CCB 8030.008

Pre and Post Change Summary

PCN #: MFOL-15LJZP349

Pre and Post Change Summary – T/R (Carrier Tape) - SOIC

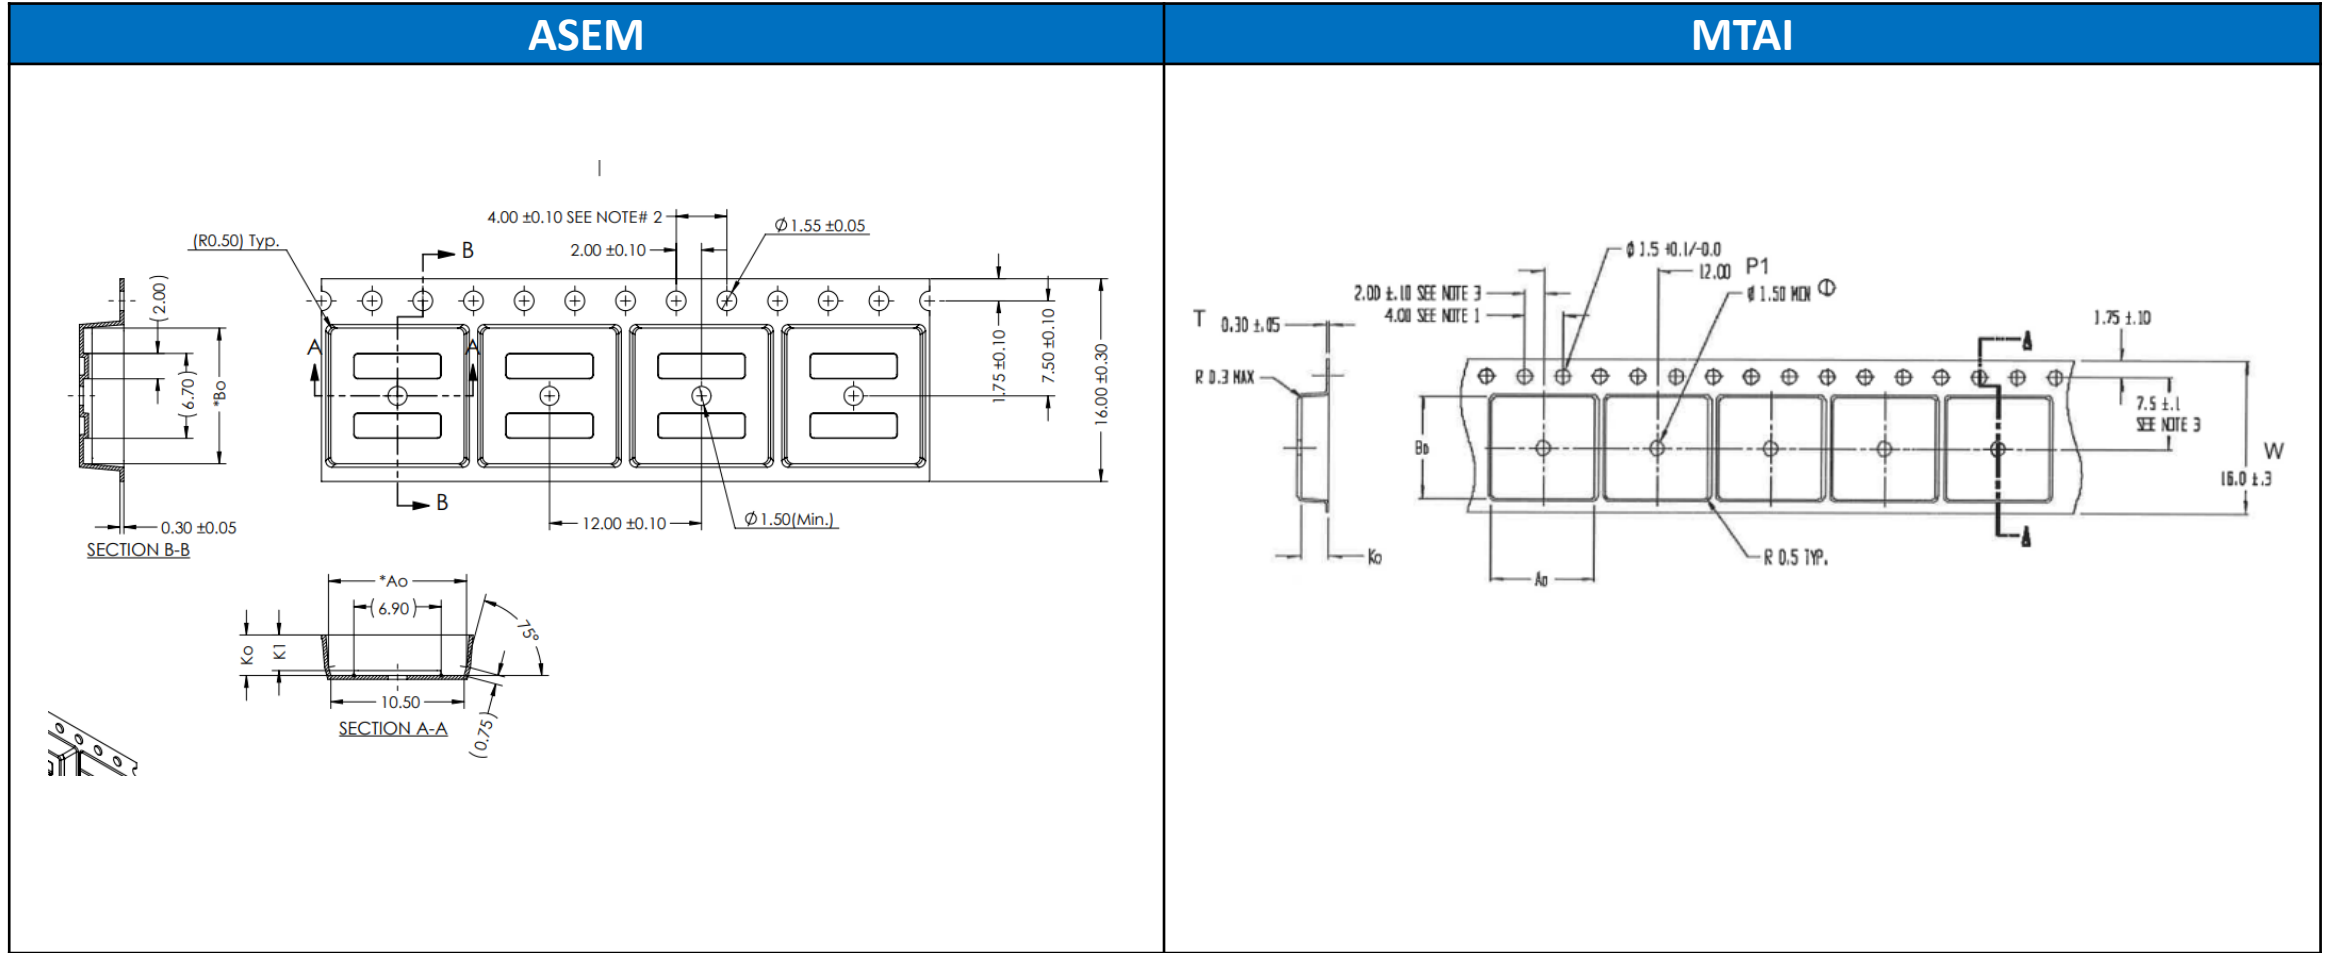
Plant	W (mm)	P (mm)	A0 (mm)	B0 (mm)	K0 (mm)	K1 (mm)	Thickness (mm)
ASEM	16.00 ± 0.30	12.00 ± 0.10	10.90 ± 0.10	10.70 ± 0.10	3.20 ± 0.10	2.80 ± 0.10	0.3 ± 0.05
MTAI	16.00 ± 0.3	12.00 ± 0.1	10.90 ± 0.1	10.70 ± 0.1	3.00 ± 0.1	-	0.30 ± 0.05

Pre and Post Change Summary – T/R (Cover Tape) - SOIC

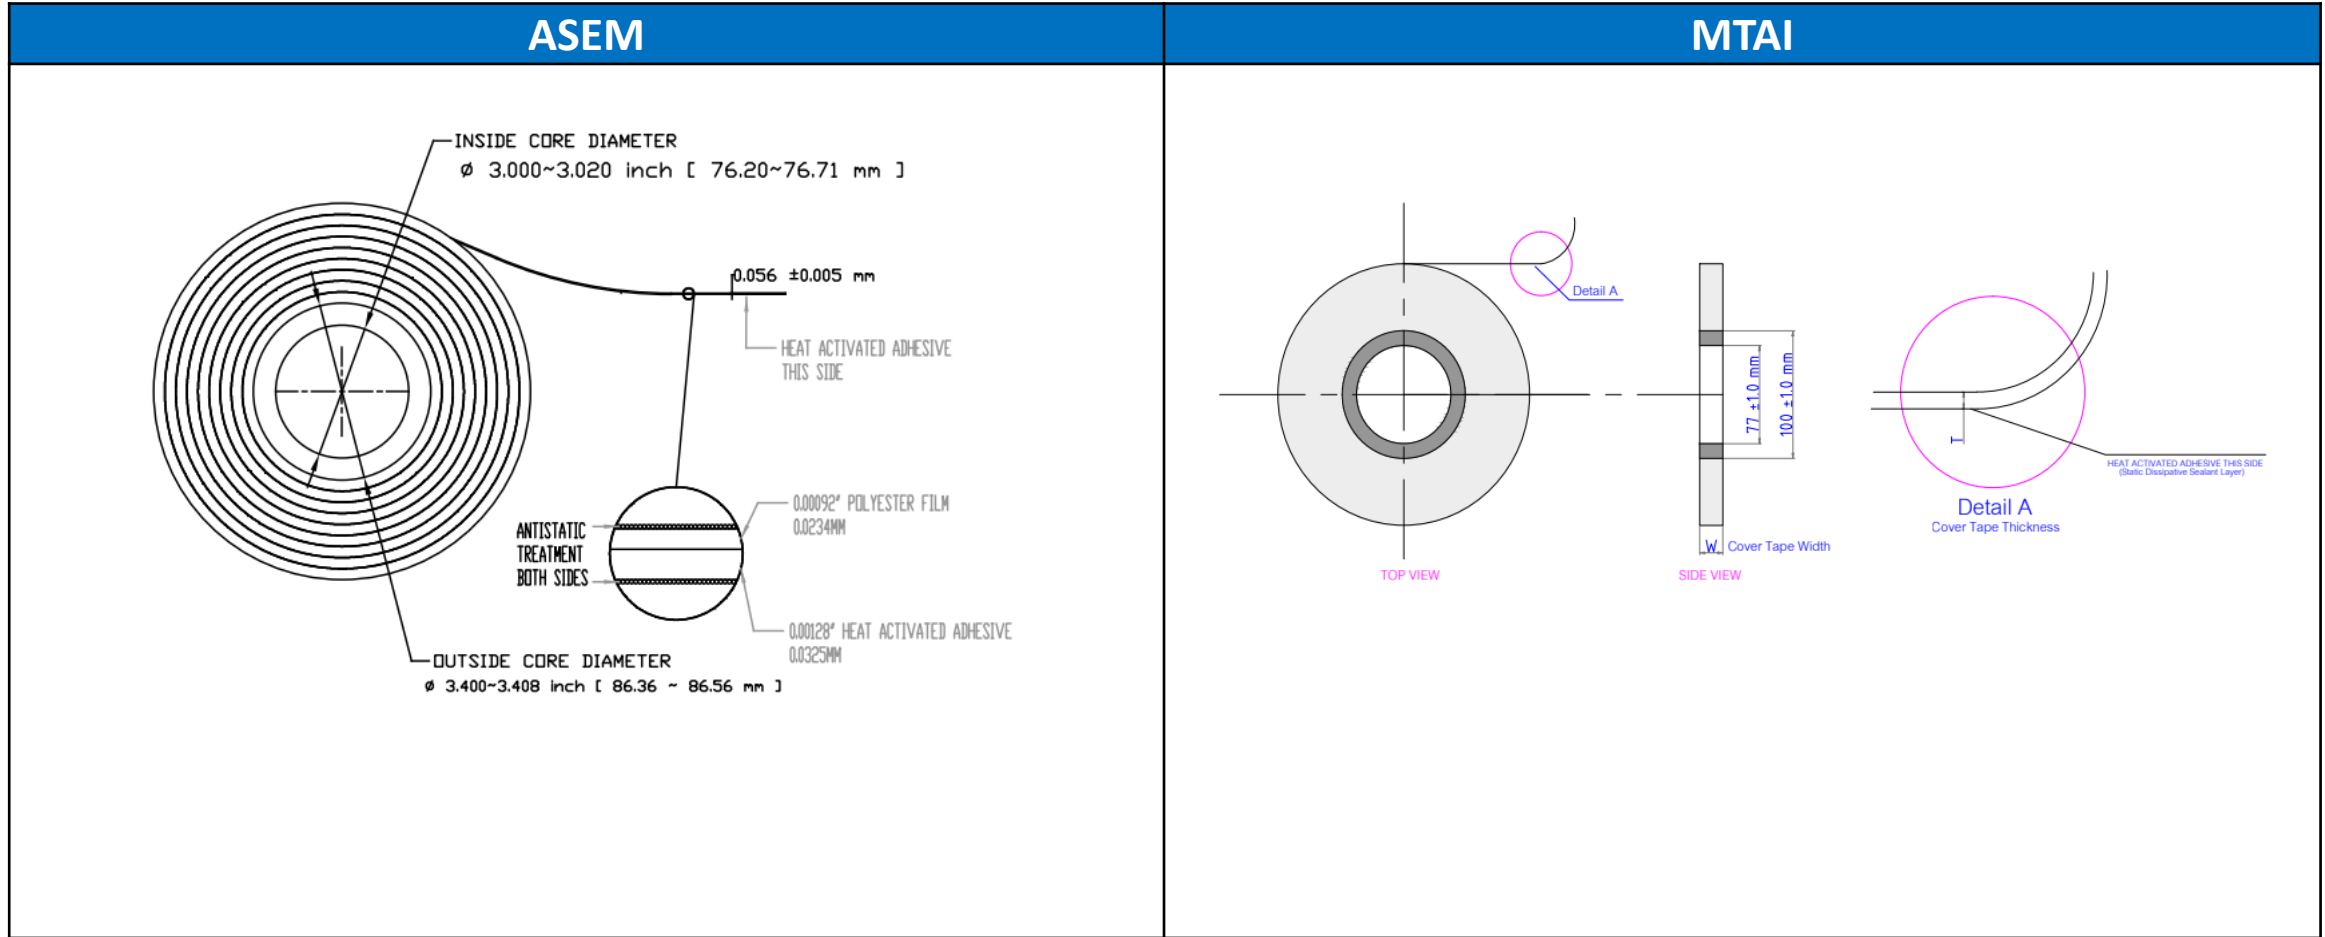
Plant	Width W (mm)	Thickness T (mm)	Color	Sealing Methodology
ASEM	13.3 ± 0.1	0.056± 0.005	Clear	Heat sealing
MTAI	13.3 ± 0.1	0.050 ± 0.010	Clear	Heat sealing

Pre and Post Change Summary – T/R (Plastic Reel) - SOIC

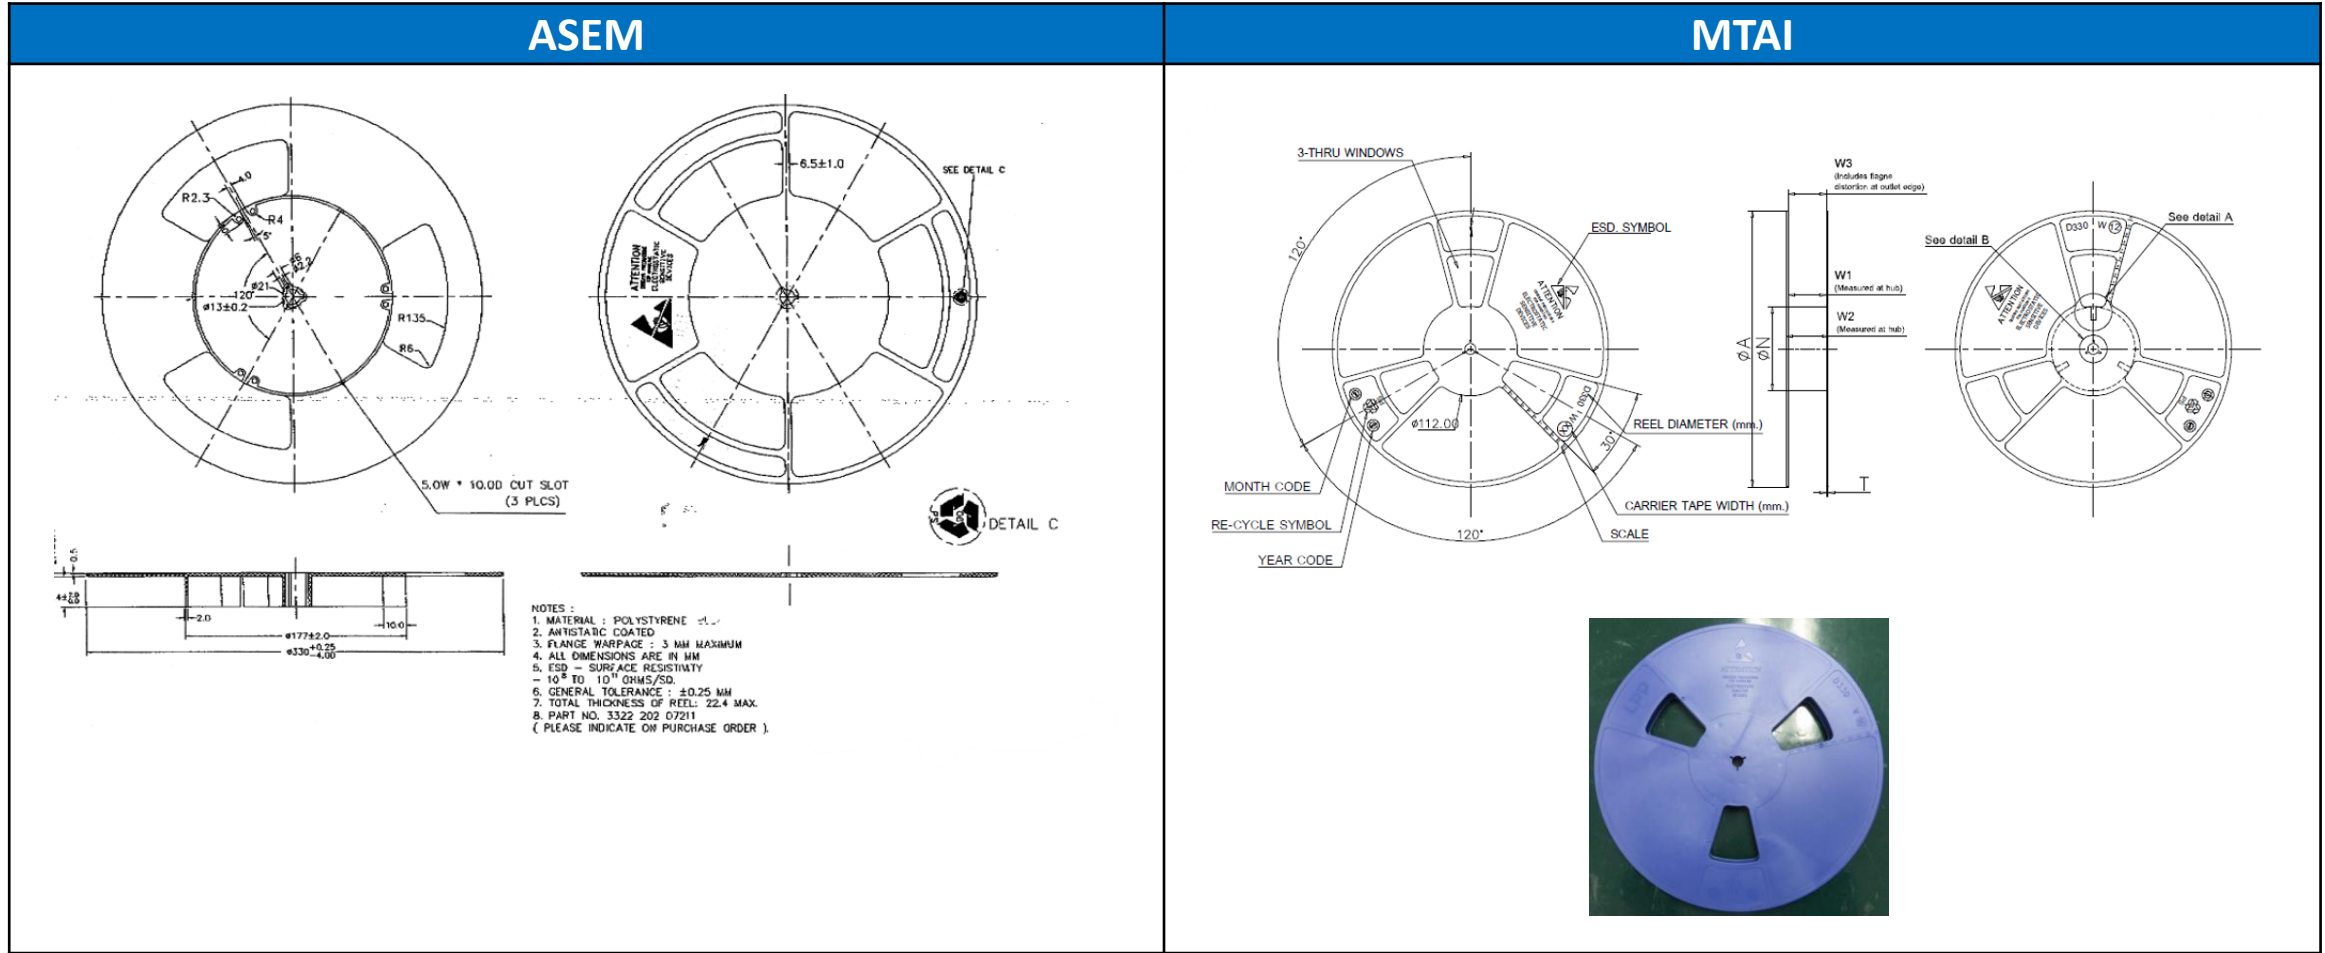
Plant	Reel Diameter (mm)	Reel Hub Size (mm)	Reel Width Max (mm)	Color
ASEM	330+0.25/-4.00	177±2.0	22.40	Dark Blue
MTAI	330 ±2	100 ±2	22.40	Dark Blue

Pre and Post Change Summary – T/R (Static Shielding Bag) - SOIC

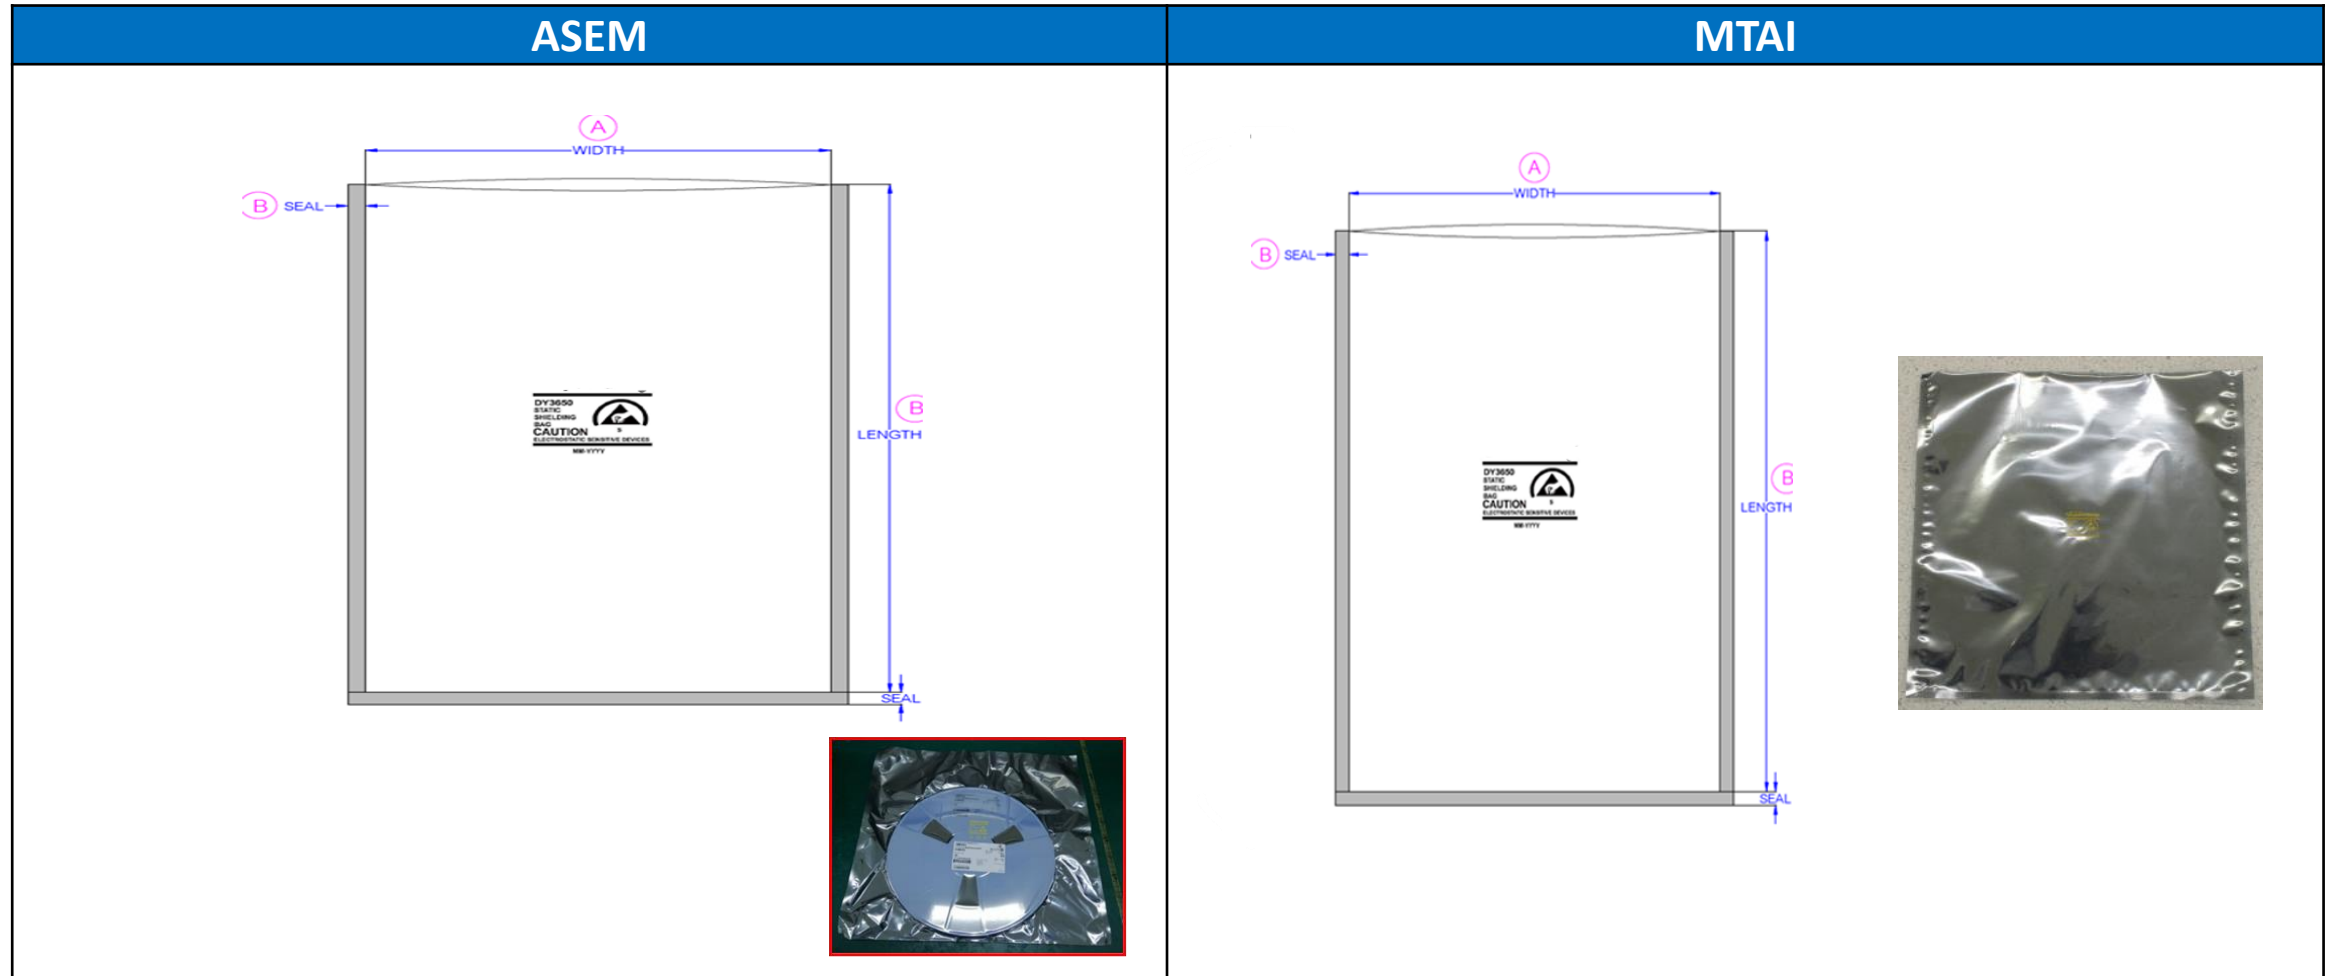
Plant	Bag type	Length (mm)	Width (mm)	Thickness (mm)
ASEM	Static Shielding Bag	457±5.00	457±5.00	0.0762
MTAI	Static Shielding Bag	420 +5/-0	370 +5/-0	0.0762

Pre and Post Change Summary – Tube - SOIC

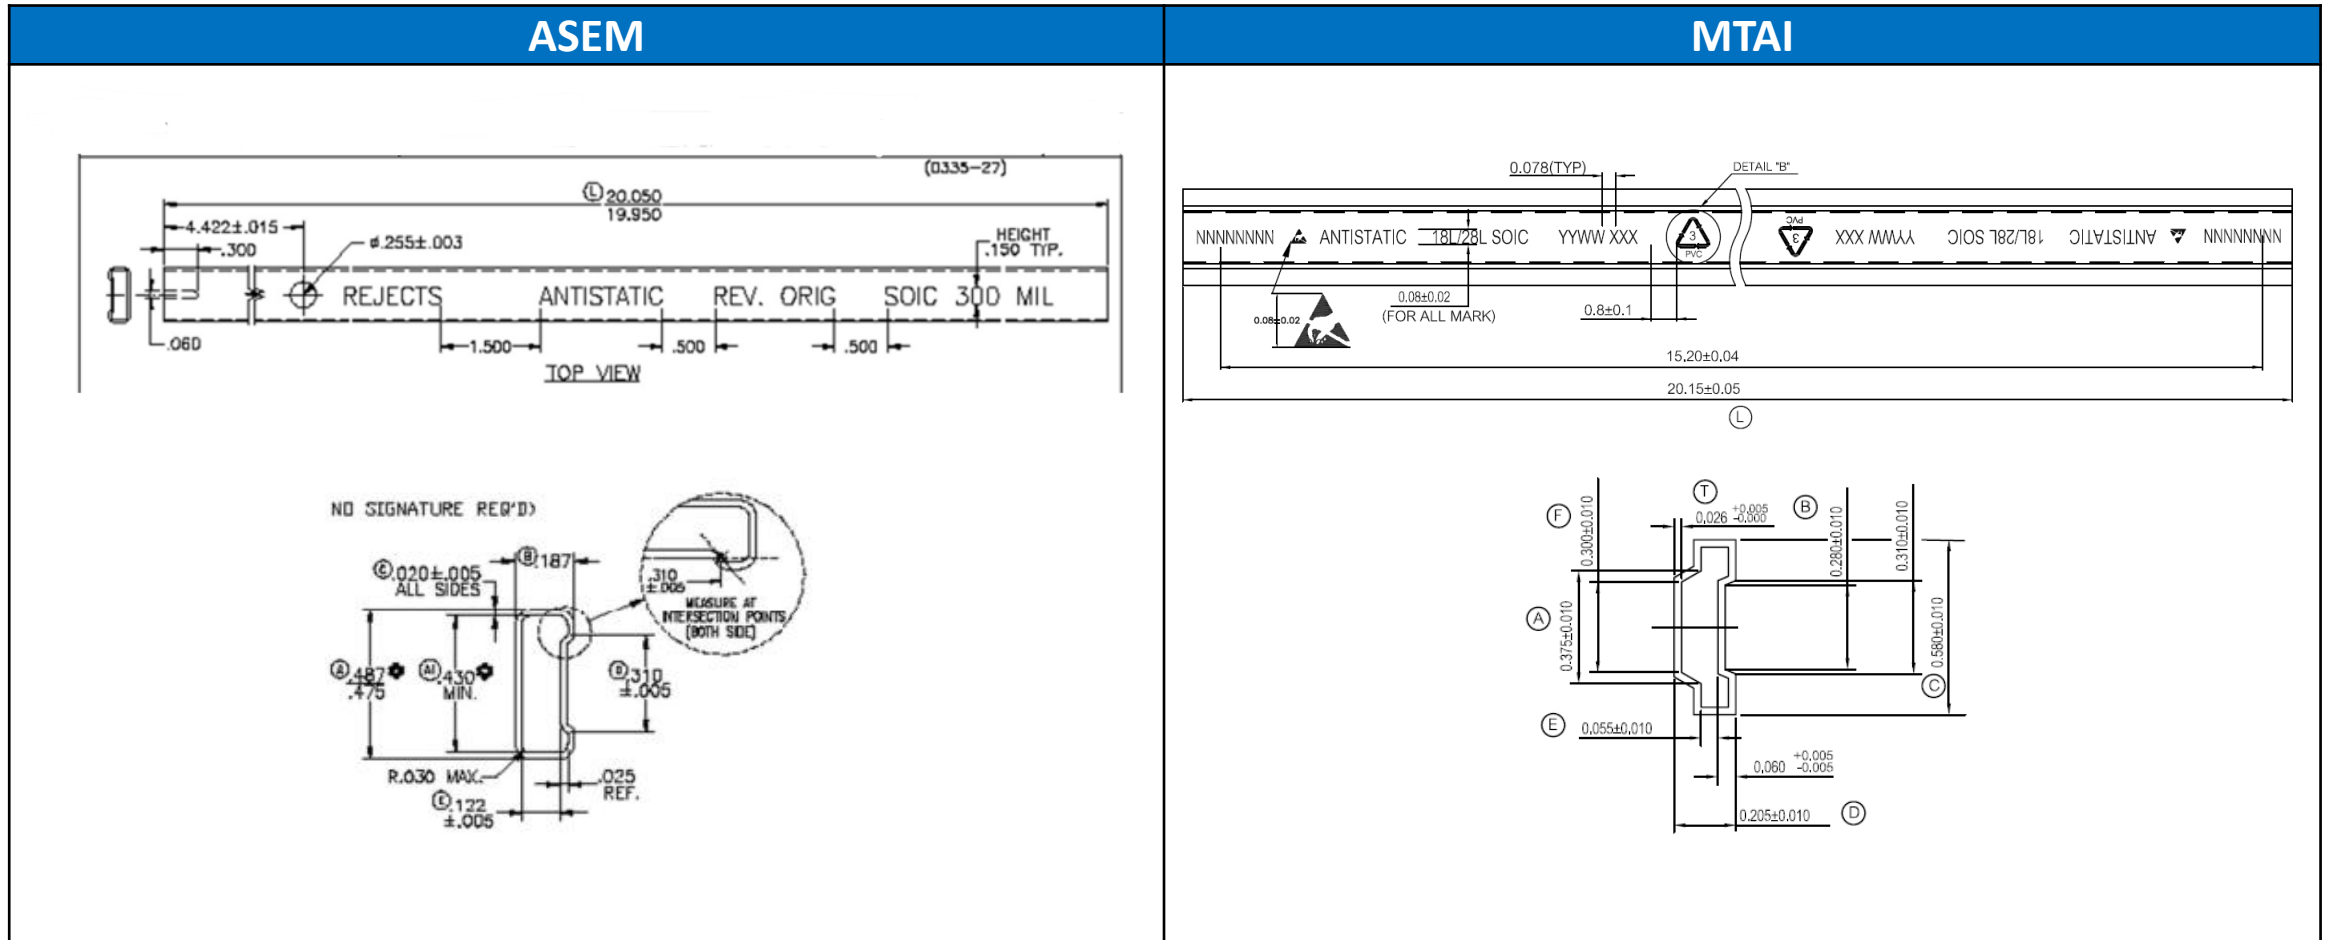
Plant	Tube Length (inch)	Tube Color	Unit per Tube	Tubes per Bag
ASEM	20.00 ± 0.05	Clear	46	25
MTAI	20.15 ± 0.05	Clear	46	40

Note: The standard MTAI packing is 47 units per tube. The quantity per tube shown in the table above will support MASK: 1H001, 1H002, 1H010, 1H013, 1H015, V8013, V8014, V8015, V8016, V8031 transfer to MTAI only.
